Request for Grant of Permission- Engineering Response (South Dublin County Council Register Reference SDZ22A/0006)

Phase 2 Proposed Development at Tandy's Lane Village,
Adamstown, Co. Dublin

Client Name: Quintain Developments Ireland Ltd.
Document Reference: 21-058r.007
Project Number: 21-058

Figure 1: Amendment to the northwesternmost intersection with two-way turning.

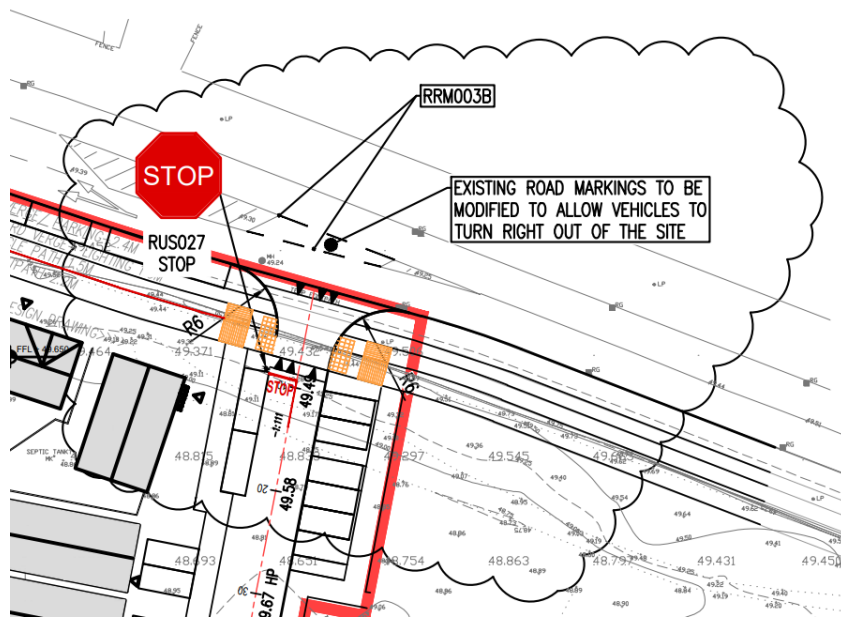
iv. Layout plan(s) of all access junctions including any alterations to the existing roads layout to make two-way turning possible. The north-westernmost junction to Adamstown Drive (L1030) shall be amended to allow turning in both directions.

The north-westernmost junction to Adamstown Drive (L1030) has been amended to allow for turning in both directions. The Modifications made to the existing L10130 painted road island as shown allow for the required turning movements, see Figure 1.
